2016-20039

Qualified Watershed Protection Plan

Phase II

The View on the Square

WATERSHED PROTECTION PLAN PH 2
GRADING & DRAINAGE PLAN

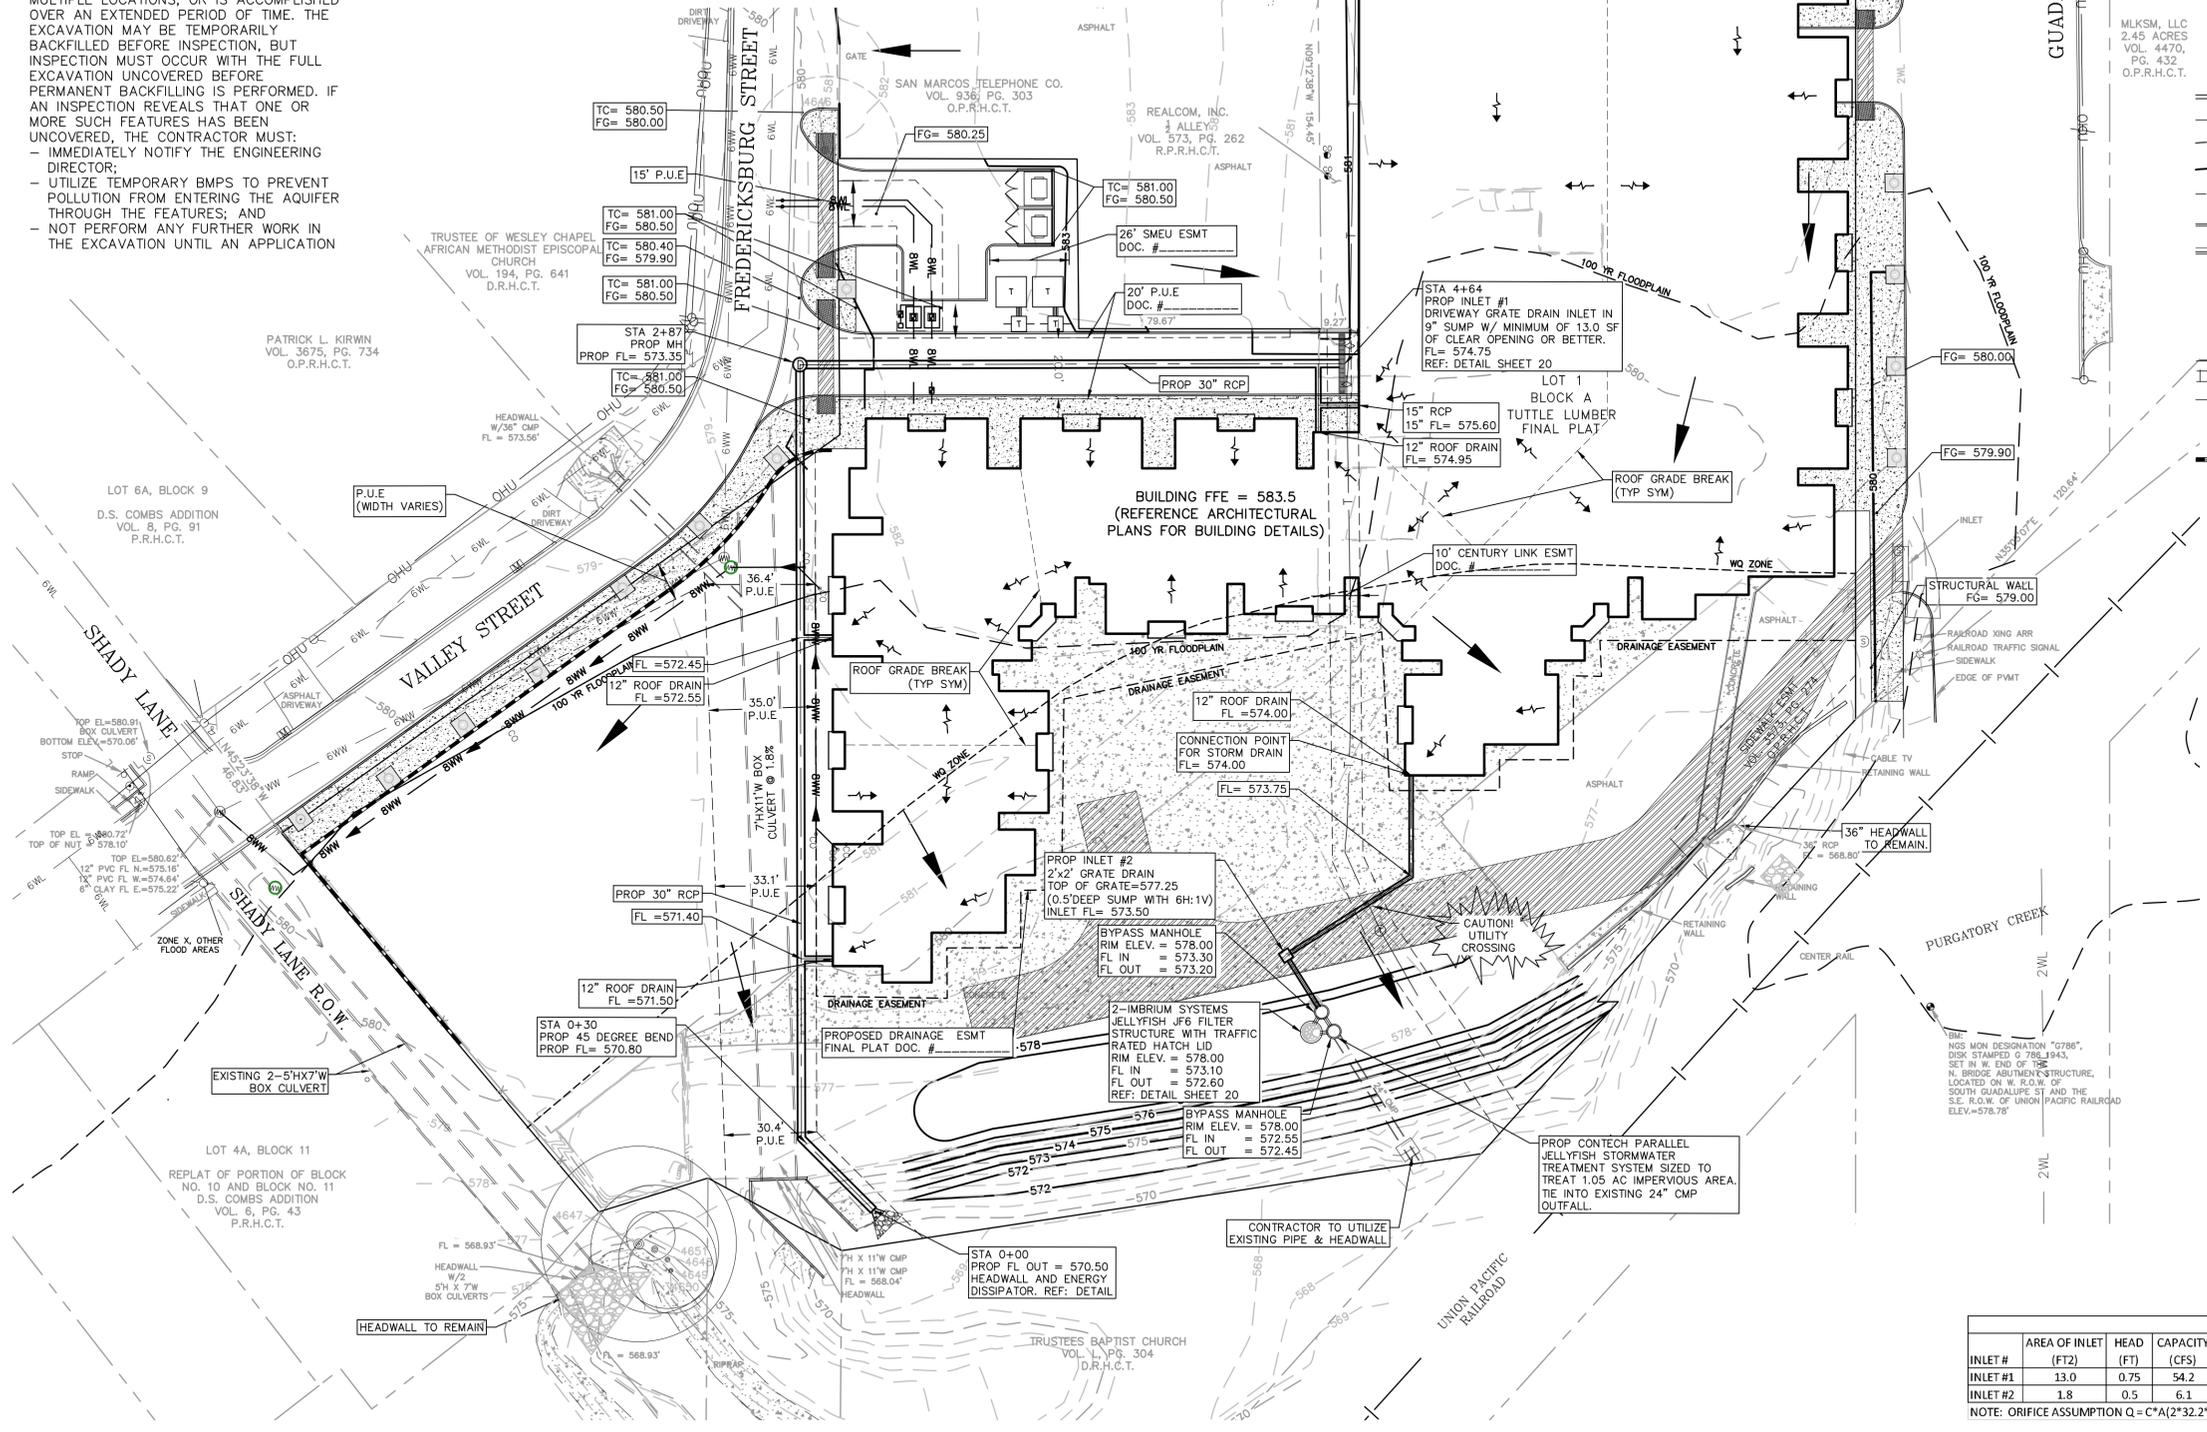
Temporary erosion control measures shown to be implemented during construction appear adequate except for the following:

- Include note on the Erosion and Sedimentation Control Plan that specifies the revegetation of the excavated slope in a way that meets COSM revegetation standards and requires the installation of soil retention blanket per COSM soil retention blanket detail.
- Show silt fencing at the bottom of the excavated slope on the Erosion and Sedimentation Control Plan.

Staff provides this request to the Commission for your consideration and recommends approval with the condition that a revised set of plans are provided addressing the temporary erosion control plan inadequacies noted above.
